SUBJECT: ISSUANCE OF AMENDMENTS (TAC NOS. 64863 AND 64864)

PACIFIC GAS AND ELECTRIC COMPANY  
DIABLO CANYON NUCLEAR POWER PLANT, UNIT 1  
DOCKET NO. 50-275  
AMENDMENT TO FACILITY OPERATING LICENSE

PACIFIC GAS AND ELECTRIC COMPANY  
DIABLO CANYON NUCLEAR POWER PLANT, UNIT 2  
DOCKET NO. 50-323  
AMENDMENT TO FACILITY OPERATING LICENSE

SAFETY EVALUATION BY THE OFFICE OF NUCLEAR REACTOR REGULATION  
RELATED TO AMENDMENT NO. 20 TO FACILITY OPERATING LICENSE NO. DPR-80  
AND AMENDMENT NO. 19 TO FACILITY OPERATING LICENSE NO. DPR-82  
PACIFIC GAS AND ELECTRIC COMPANY  
DIABLO CANYON NUCLEAR POWER PLANT, UNIT NOS. 1 AND 2  
DOCKET NOS. 50-275 AND 50-323

Figure 6.2-1 Offsite Organization

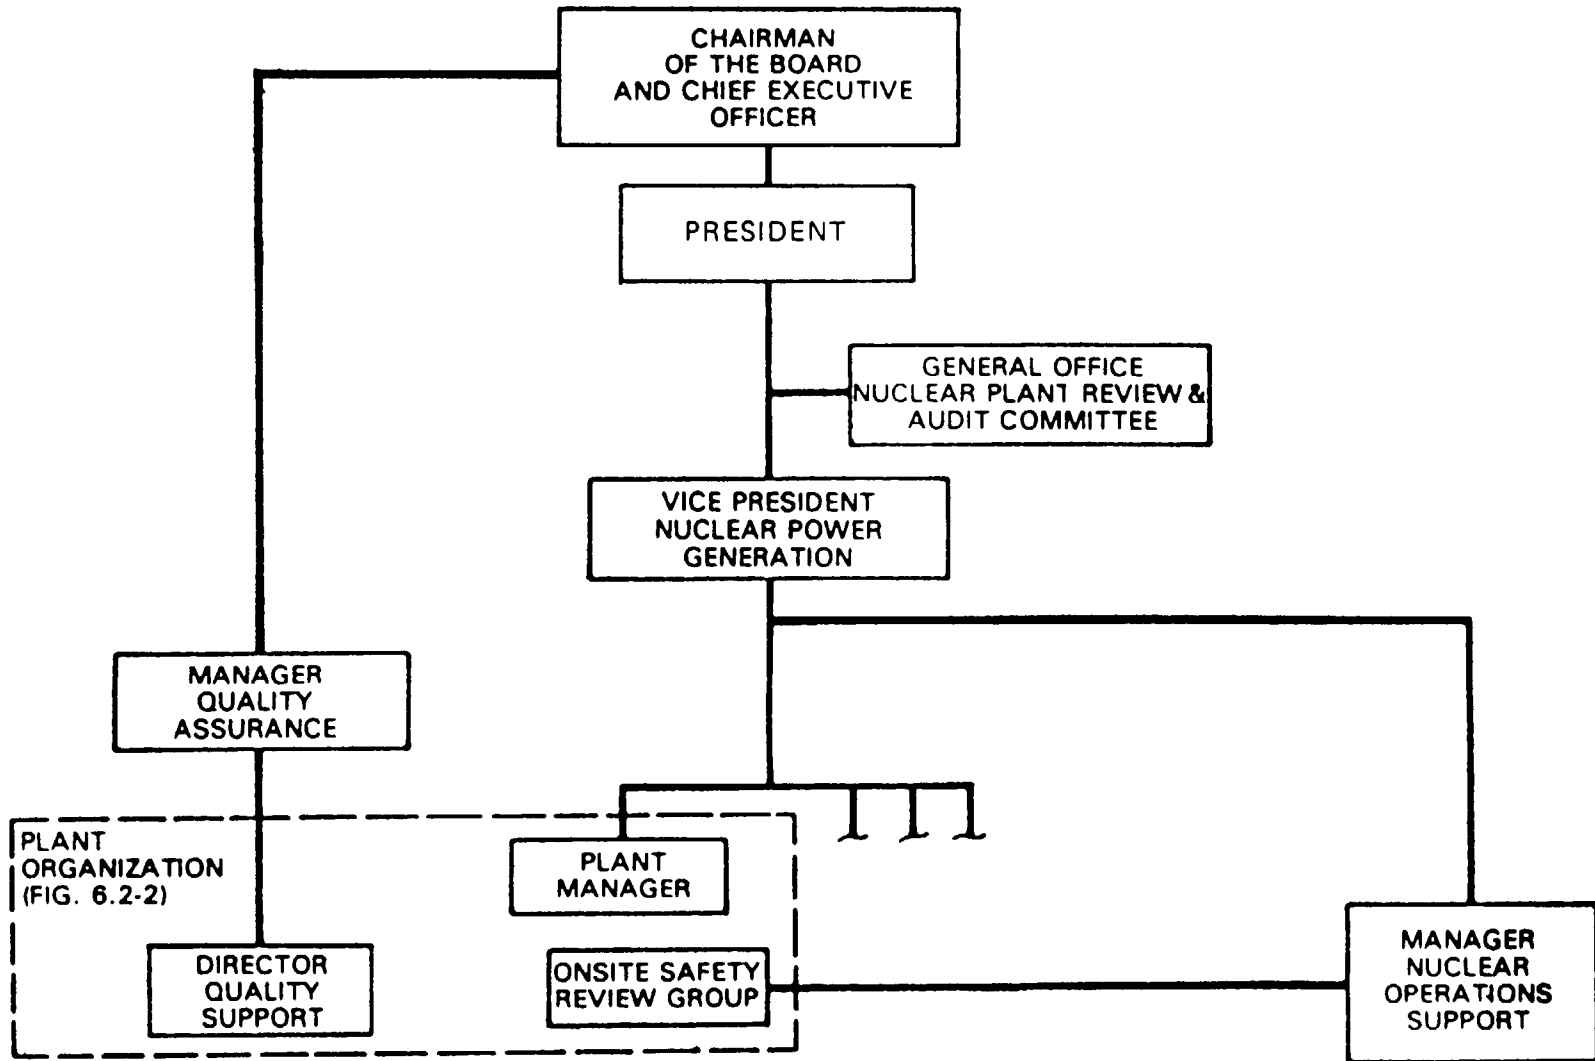
The changes to Technical Specification Figure 6.2-1 and Technical Specifications 6.5.2 and 6.7 reflect PG&E corporate organizational changes. The position of Executive Vice President, Facilities and Electric Resources Development, was eliminated. The Vice President, Nuclear Power Generation, now reports to the President. This does not represent any significant change to the nuclear organization responsible for the operation of Diablo Canyon and is acceptable.

Figure 6.2-2 Plant Organization

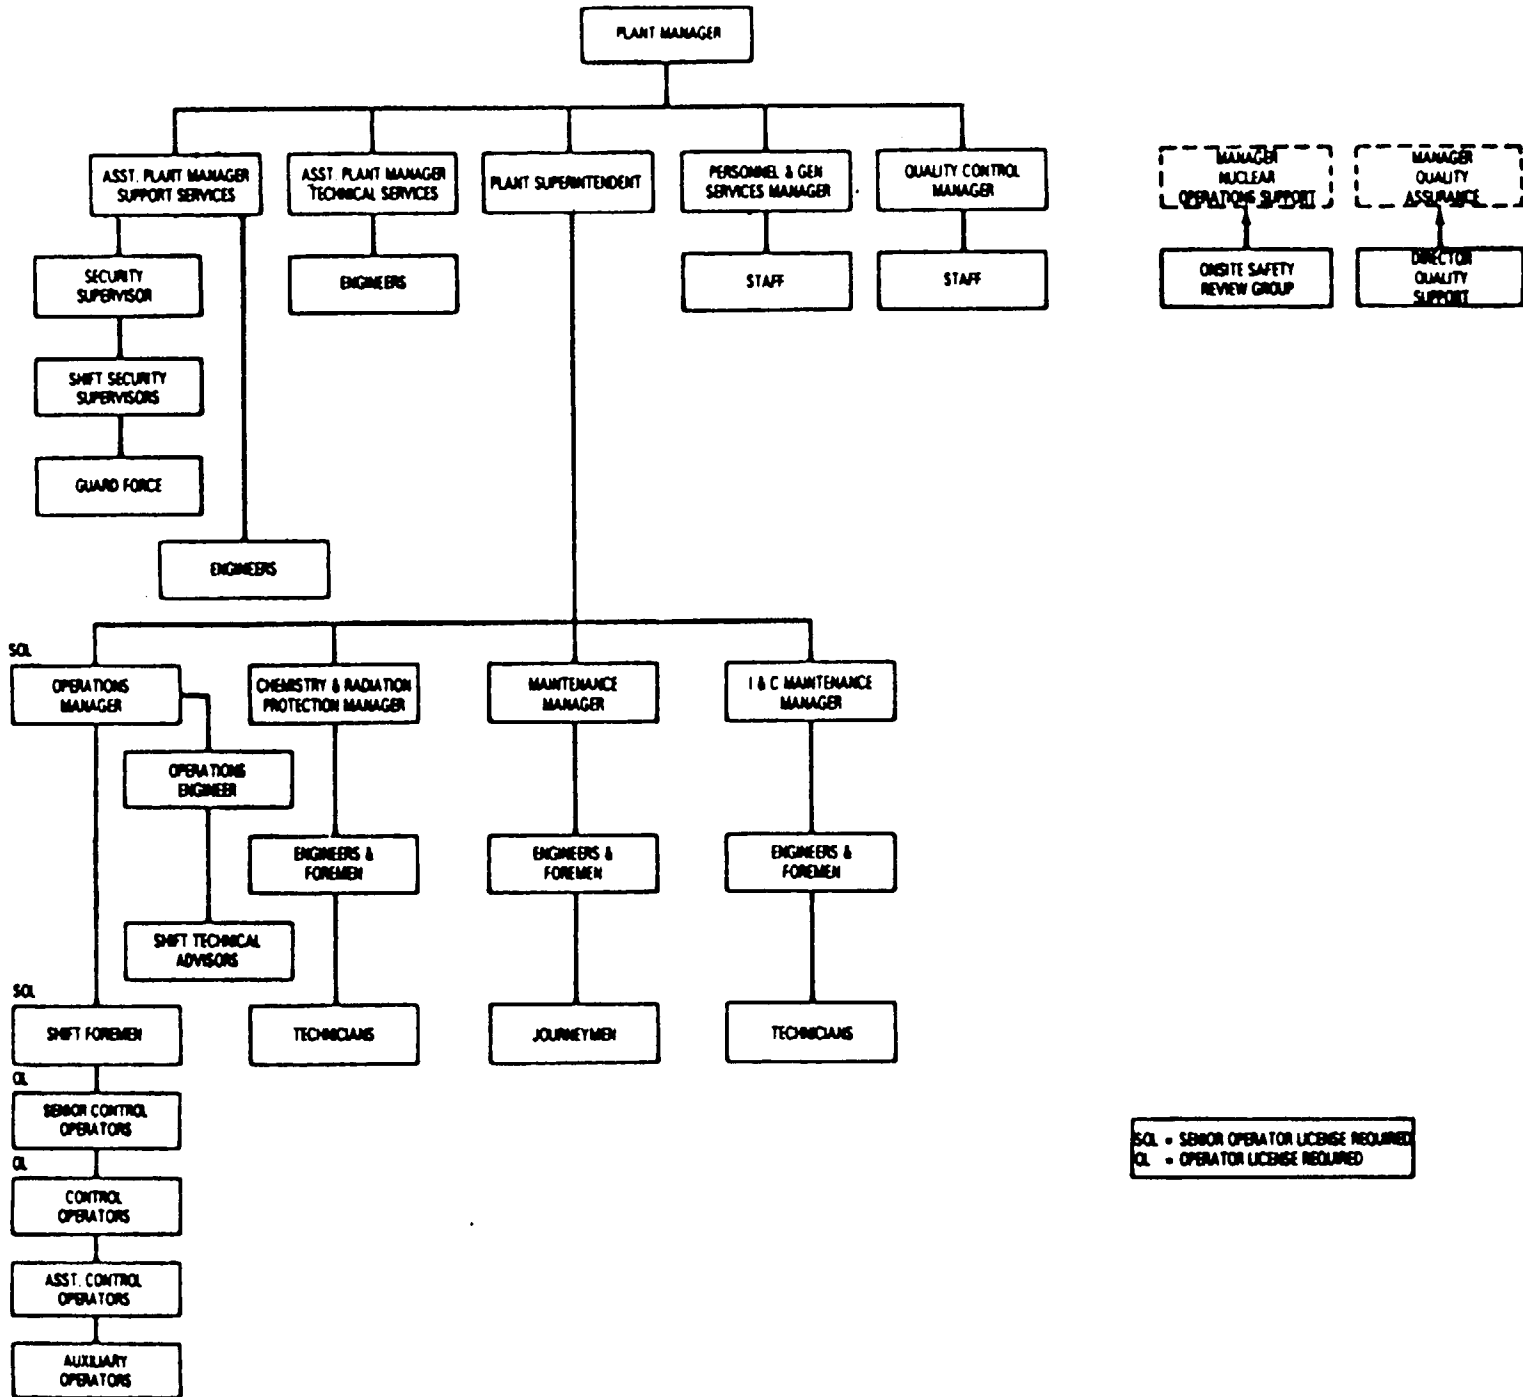
The change to Technical Specification Figure 6.2-2 reflects a plant organizational change. The plant security organization would now report to the Assistant Plant Manager-Support Services in order to provide additional management oversight of the security organization activities. This should allow closer supervision of the security function by upper-level plant management and is acceptable.
